STEAM GENERATOR TUBE INSPECTION DISCUSSION DURING PALISADES 2017 (1R25) OUTAGE (Preliminary Information)

Currently Palisades is ~ 93% through the base scope eddy current inspection and starting the special interest inspection scope as of 5/5/2017 at ~ 0430 hours

The following is the primary to secondary leak trend for the last fuel cycle
Note: Units in gallons per day

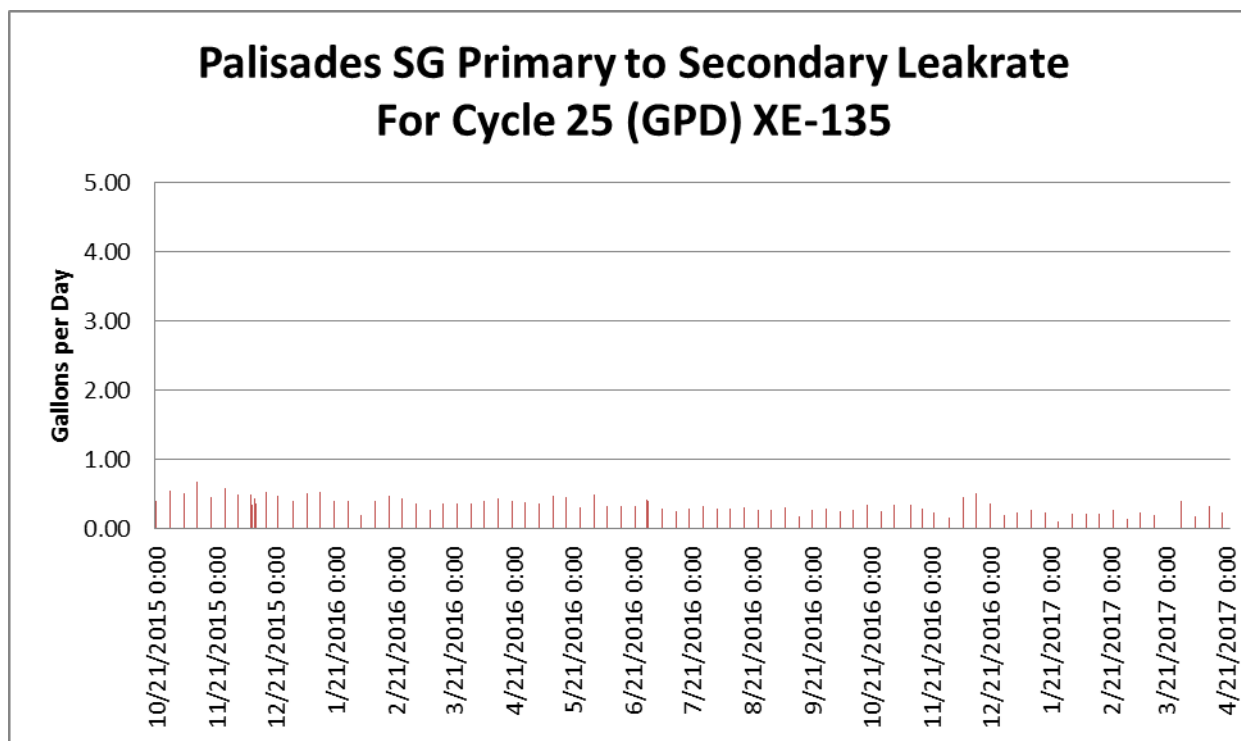
1. Discuss any trends in the amount of primary-to-secondary leakage observed during the recently completed cycle.

Refer to attached Primary to Secondary Leak Rate for Operational Cycle 25 Primary to Secondary Leak Rate graph. Leakage has been minimal all cycle.
